| <i>Recall Bulletin</i> | <i>RCL-08-003</i> |

Subject: 1098 Rear Sprocket

Models: 1098/1098S/1098 Tricolore M.Y. 2007 and 2008

NHTSA CAMPAIGN I.D. Number: 08V-253
Transport Canada Safety Recall I.D. Number: 08-175

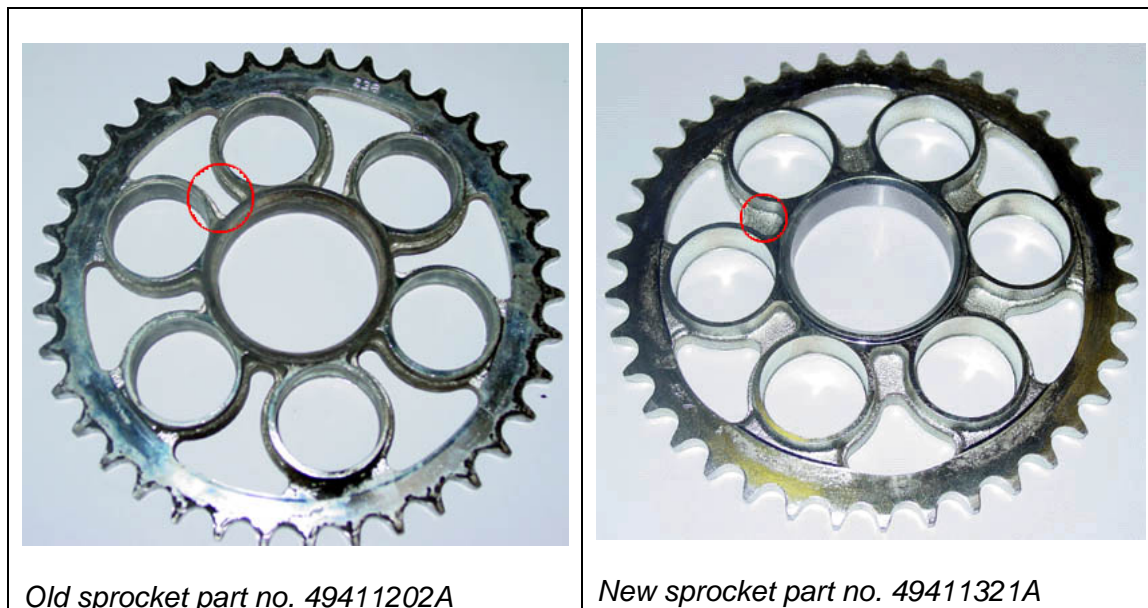
Ducati Motor Holding S.P.A. has decided that the final drive sprocket (rear sprocket), installed during production of some M.Y. 2007 & 2008, 1098/1098S/1098 Tricolore motorcycles, may fail. This non-conformity may cause the sprocket to break at the points where it encapsulates the cush drive dampers. If the sprocket were to fail while the motorcycle is being driven, it is possible that the motorcycle will experience a sudden loss of power and/or the chain may become entangled with the chassis. This can result in a crash without prior warning.

The sprocket was modified. Material has been added to the sections between the cush drive damper mounting points, thereby increasing their strength. The area where the material has been added is circled, in red, in the images below.

Sprocket part no. 49411202A was superseded by the new sprocket part no. 49411321A

Production implemented the revised sprocket, as of 12/5/2007, from frame no. ZDM1XBEW38B014360.

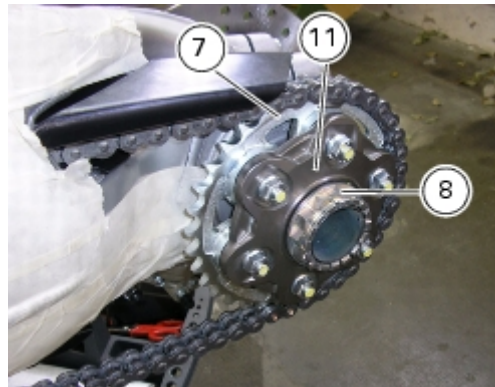
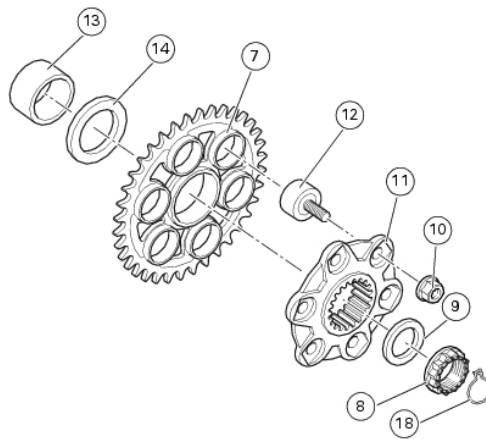
- Hold the axle against rotation.
- Remove the circlip (18).
- Using a socket wrench, loosen the lock nut (8).
- Fully unscrew the nut (8) and remove the washer (9) and the flange (11) complete with the rear sprocket (7).
- Recover the spacer (14).
- Using a mallet, tap the sprocket flange (11) with the cush drive bushes (12) off the sprocket (7).

Refitting the rear sprocket

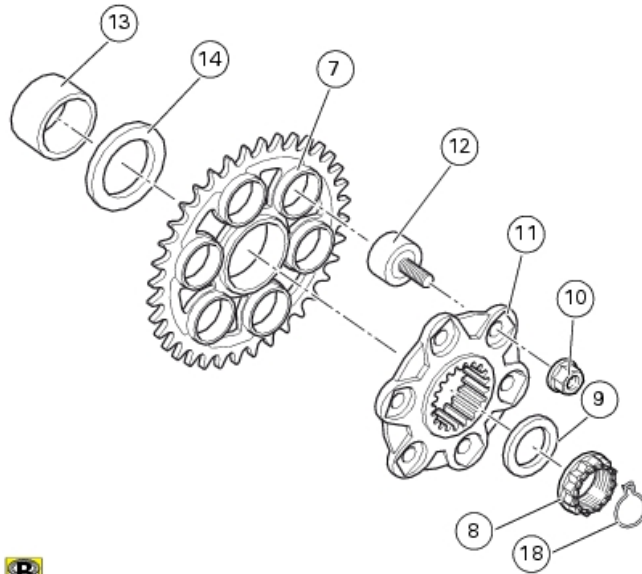
- Refitting is the reverse of removal.
- If it was necessary to remove the cush drive bushes (12), grease all the mating surfaces and the undersides of the retaining nuts (10) of the cush drive bushes (12) with the recommended grease.
- To refit the nut (8), follow the instructions given for the axle nut in *Section G4, Refitting the rear wheel*.

➤ We remind you that the tightening torque to be used when tightening the nut (8) on the sprocket flange is 230 Nm
